MECKLENBURG COUNTY
HEALTH DEPARTMENT

Re: Application for improvement permit for: 2 Bedroom House
Property Location: 9821 Earney Dr, Charlotte, NC 28214 (PID 031-121-17)
Health Department File Number: **10783B (App ID 11693)**

SOIL/SITE EVALUATION for ON-SITE WASTEWATER SYSTEM

Sketch of Soil Evaluation Locations

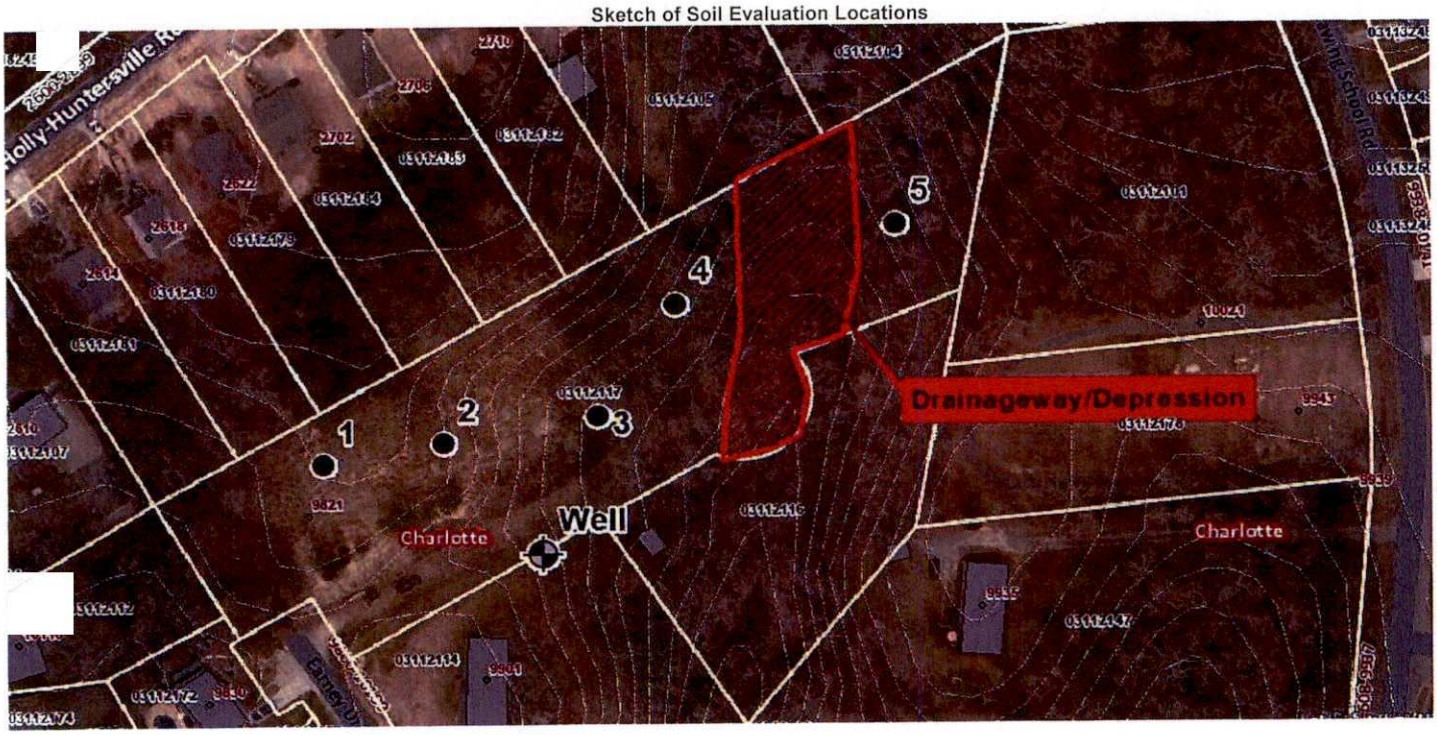
Based on the criteria set out in Title 15A, Subchapter 18A, of the North Carolina Administrative Code, Rules .1940 through .1948, the evaluation indicated that the site is **UNSUITABLE** for a ground absorption sewage system. Therefore, your request for an improvement permit is **DENIED.** A copy of the site evaluation is enclosed. The site is unsuitable based on the following:

- ☒ Unsuitable soil topography and/or landscape position (Rule .1940)
- ☒ Unsuitable soil characteristics (structure or clay mineralogy) (Rule .1941)
- ☒ Unsuitable soil wetness condition (Rule .1942)
- ☒ Unsuitable soil depth (Rule .1943)
- ☐ Presence of restrictive horizon (Rule .1944)
- ☒ Insufficient space for septic system and repair area (Rule .1945)
- ☐ Unsuitable for meeting required setbacks (Rule .1950)
- ☐ Other (Rule .1946)

PROFILE #	.1940 Landscape Position/ Slope%	Horizon Depth (IN.)	SOIL MORPHOLOGY .1941 .1941 Structure/ Texture	.1941 Consistence Mineralogy	b PROFILE FACTORS .1942 Soil Wetness/ Color	.1943 Soil Depth (IN.)	.1956 Sapro Class	.1944 Restr Horiz	General Comments	Profile Class & LTAR	Maximum Trench Bottom Depth for 3' Wide Conventional Trench
Boring #1	SS 5%	0 - 14	mass C	S VP VFI EXP	10YR 6/1 at 3"	14	NA	NA	grinding through soil with auger 14 - 18"	US	NA
		14 - 18	Saprolite								
		18	Auger Refusal								
Boring #2	LS 9%	0 - 14	Fill		10YR 6/1 at 16"	0	NA	NA		US	NA
		14 - 25	mass C	S VP VFI EXP							
Boring #3	LS 6%	0 - 8	gr SCL	SS SP FR SEXP	2.5Y 8/1 at 16"	16	NA	NA	very wet 0 - 20"	US	NA
		8 - 16	sbk SCL	SS SP FR SEXP							
		16 - 22	sbk C	S VP VFI EXP							
Boring #4	LS 6%	0 - 2	gr SL	SS SP FR SEXP	10YR 7/1 at 3"	20	NA	NA		US	NA
		2 - 20	mass C	S VP VFI EXP							
		20	Auger Refusal								
Boring #5	HS 6%	0 - 6	gr SCL	SS SP FR SEXP	10YR 7/1 at 12"	12	NA	NA		US	NA

6 - 12	sbk SCL	SS SP FR SEXP							
		12 - 25	mass C	S VP VFI EXP

Description	Initial System	Repair System
Available Space (.1945)	US	US
System Type(s)	NA	NA
Site LTAR (gpd/sq ft)	**US**	**US**

Other Factors (.1946):
Soil Evaluation By: Jacob Presley, REHS, LSS
Others Present:
Site Classification (.1948): Unsuitable
Site Evaluation By: Jacob Presley, REHS, LSS
Others Present:

COMMENTS: There are large spoil piles in the area of borings 2 and 3. There is a cut and driveway near the south property line.
